# Decision Document

**Licensee:** St Barbara Limited

**Licence:** L8337/2009/2

This Licence amendment is a result of the Licensee applying to construct a new landfill near Gwalia Deeps, and to construct and operate a new Tailings Storage Facility 4 (TSF4) on top of Grant's Patch TSF and the Licence being converted to the new format.

Figure 6: Location of proposed new landfill adjacent to Gwalia Deeps

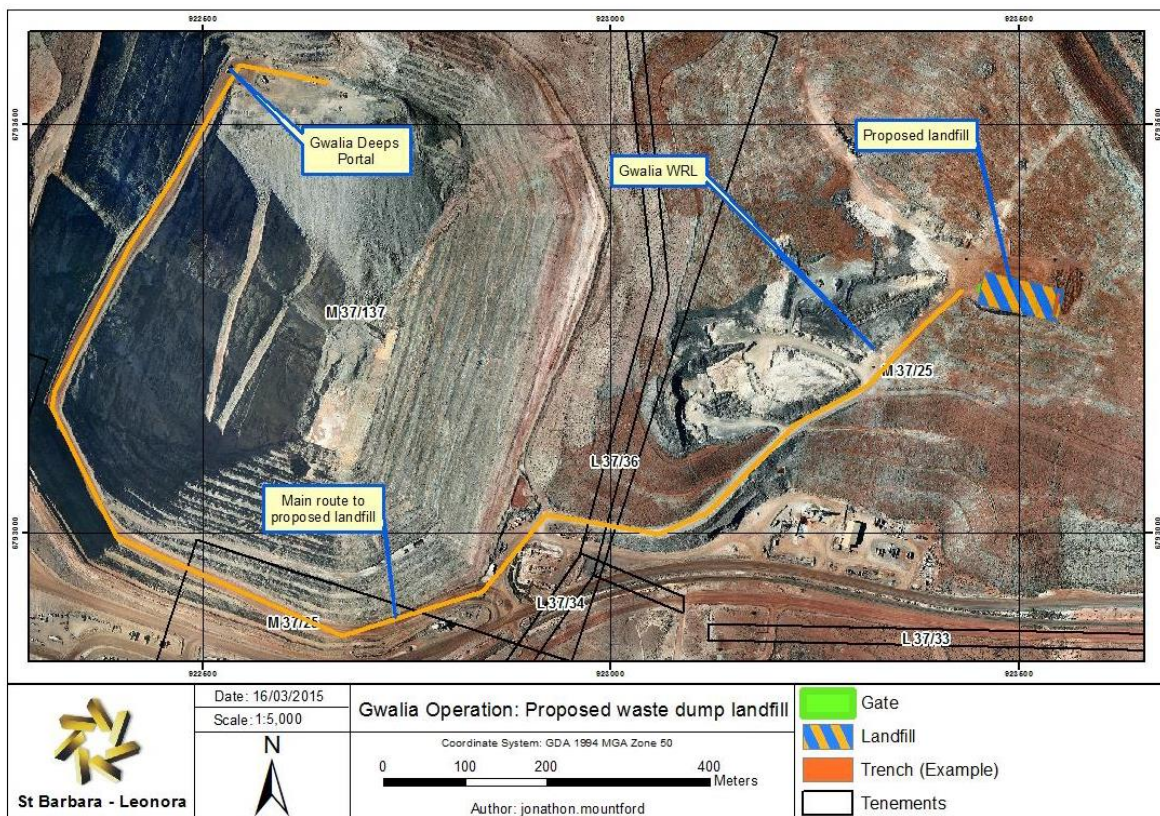
St Barbara Limited (SBM) intends to construct, commission and operate a class II landfill on a historic waste rock landform (WRL) immediately east of the Gwalia Deeps Open Pit as shown in Figure 1 below. The area has been used for temporary stockpiling of waste vent bag material from the underground operations. Originally this material was to be recycled; however that option has not proved feasible and instead SBM will landfill the waste material at the same location. SBM also intends to deposit heavy vehicle tyres to the landfill. These will be disposed of in accord with the Part 6 of the Environmental Protection Regulations

**Emission:** Uncontrolled release of putrescible waste and other light waste materials, spread via wind, feral animals, vermin.

**Impact:** Poor amenity and attraction of feral animals and additional vermin to the site

**Controls:** SBM have proposed to limit the number of open trenches to only one at a time. The Stage 2 facility will be fenced and the use of the Stage 1 facility will be limited as it is intended to dispose of waste currently stockpiled at the site. The use of the landfill will reduce the likelihood that windblown waste will eventuate; a risk currently present with stockpiled materials.

Licence condition 1.2.8 has been placed on the Licence to ensure the materials deposited to the landfill are as allowed for a Class II landfill. Condition 1.2.9 specifies the cover material for the trenches in the landfill and frequency that cover must be placed over waste materials. Licence condition 1.2.10 requires windblown waste to be periodically cleaned up. These conditions replace previous licence conditions L1 – L5.

Figure 7: Depiction of the two stages of the landfill, with an indicative trench shown.

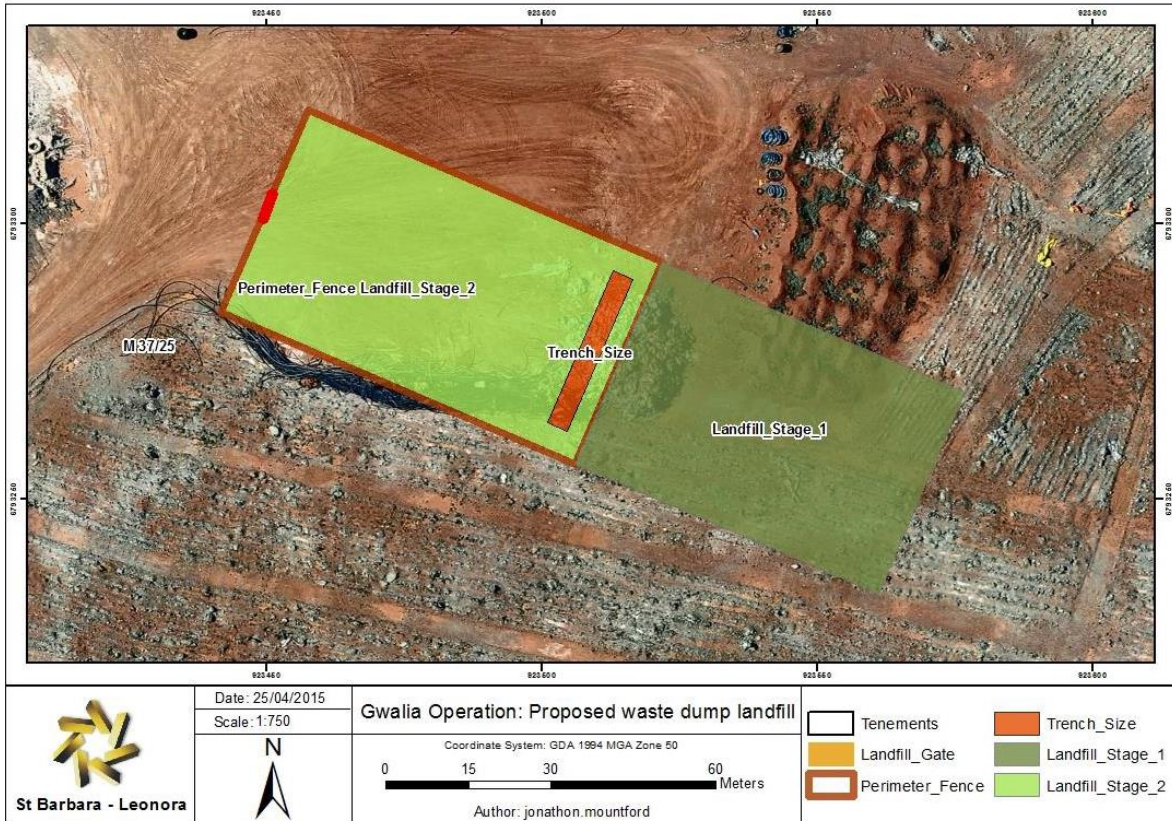
The landfill is proposed to be developed in two stages. Stage One will consist of a short-term excavation to dispose of the existing stockpiled materials and tyres. The area of Stage One will be approximately 60m x 40m. As the material will be immediately buried no fencing is proposed for Stage One.

Stage Two will consist of the long-term landfill, utilising open trenches for waste deposition. The facility's area is approximately 70m x 40m, the length of the individual trenches will not exceed 30m in length and be opened and closed sequentially so only one trench is open at any time. Refer to Figure 2 below. This section of the landfill will be fenced to prevent unauthorised access and ensure windblown wastes are retained at the landfill. The main wastes deposited into the stage 2 landfill are vent bag material, plastics, unsalvageable steel along with small amounts of putrescibles from the Gwalia Deeps underground operation.
